ARBORICULTURAL ADDENDUM

Drainage and Patio Clarification

Site	19 Salmond Road, Reading, RG2 8QN
Original AIA	Project 25_5837_11_27 - Arboricultural Impact Assessment, first issued 28 November 2025
Updated drawings	26/1938/01 - Tree Constraints Plan; 26/1938/02 - Tree Assessment Plan
Prepared by	KVL Designs Ltd
Date	17 September 2026

Drawing Title			
Tree Constraints Plan			
Client			
Shashi (Sammy) Sharma			
Site/Project			
19 Salmon Road, RG2 8QN			
Scale/Sheet		Date	
1:250 @ A3		19/11/2025	
Drawing No	Rev	Drawn By	Checked By
26/1938/01	1

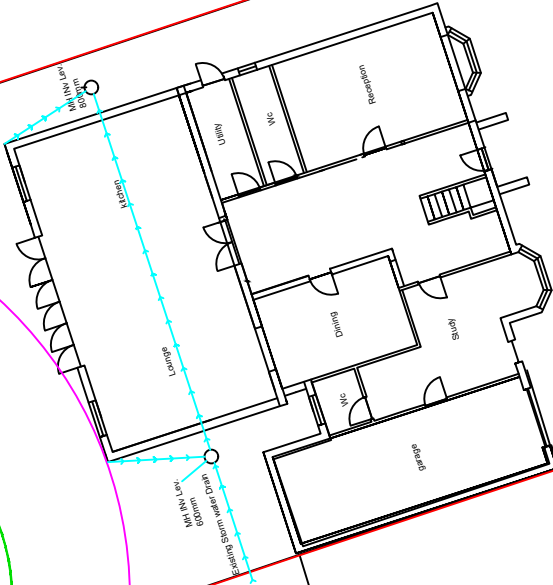
- No new soakaway is proposed as part of the current development.
- The current proposal is to use the existing storm-water drainage system and connect surface-water drainage to that existing system, as shown on the updated drawings 26/1938/01 and 26/1938/02.
- The updated drainage route is shown adjacent to the dwelling and away from the RPA of T1. No new soakaway excavation is proposed within the RPA.
- The reference to a soakaway trench in the original AIA should therefore be read as a description of the excavation observed during the earlier site inspection and not as a proposed soakaway forming part of the current planning scheme.
